GTS Newsletter

2008/17E

Machine	TASKI swingo XP
Subassembly	Tank

Induction Air Filter/Hinge

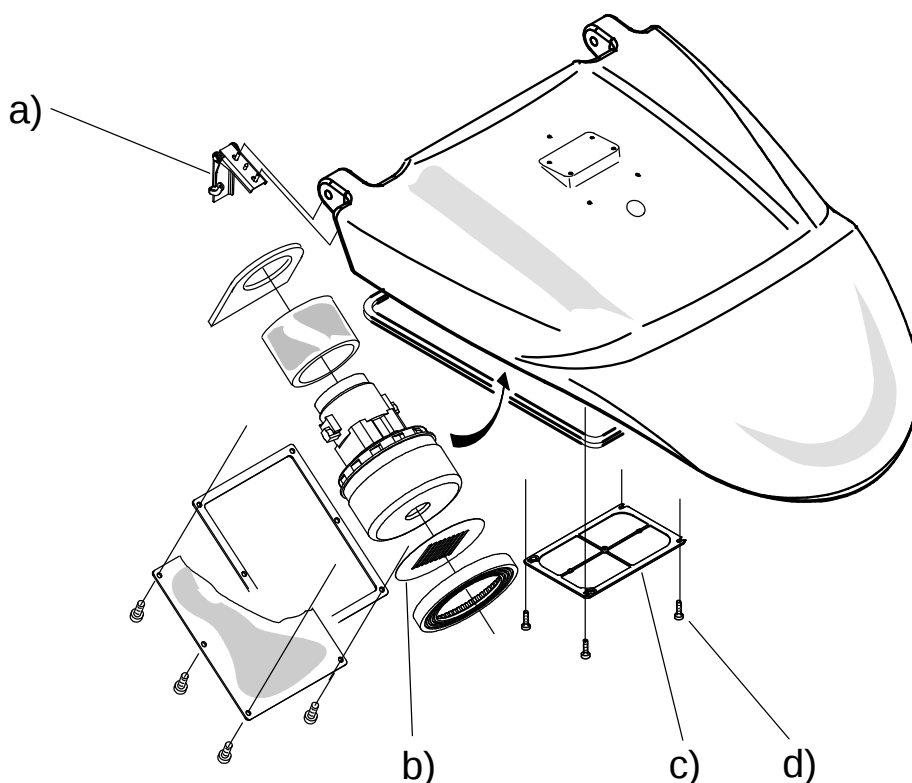
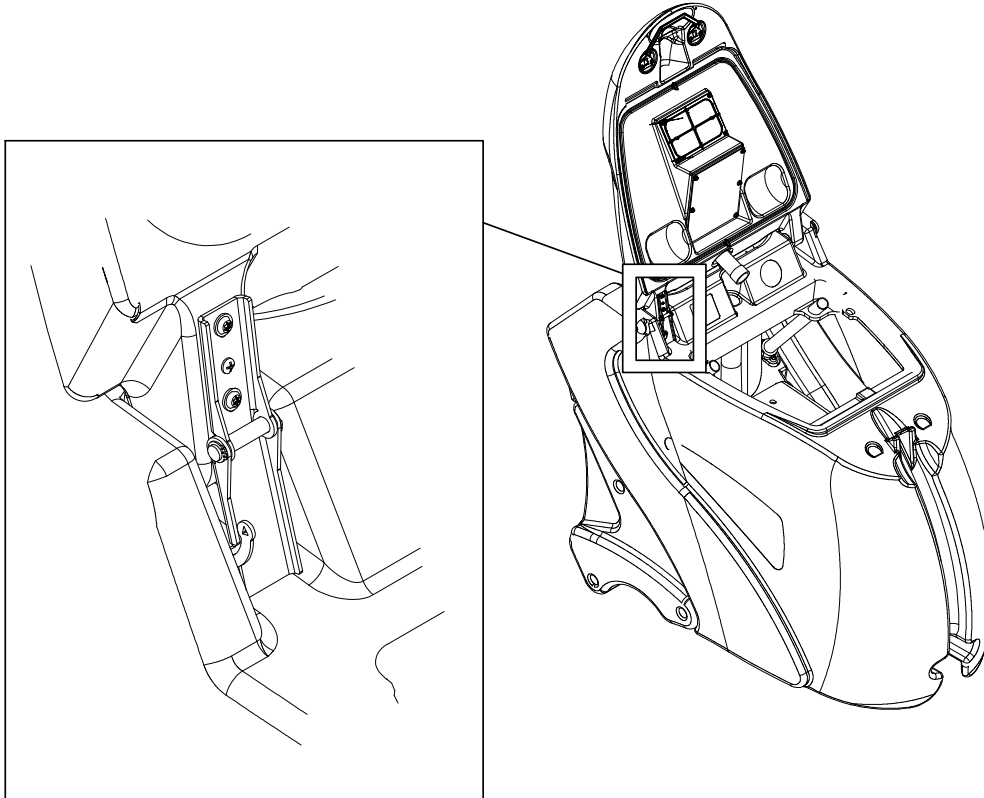
Due to safety related reasons we are forced to place a protection onto the tank cover, so it can no longer shut all of a sudden.

Furthermore an Induction Air Filter (c), which is easy removable, will be implemented. To secure that nobody is able to grasp into the turbine an additional protecting plate (b) needs to be mounted in between the turbine and the gasket.

It has to be kept in mind when replacing the old induction air filter than the protecting plate has to be mounted between turbine and induction air filter

The hinge/protection plate cannot be ordered as a set. The hinge/protection plate is not backward compatible because the strength of the lid is not designed according to that.

as of machine number 02876
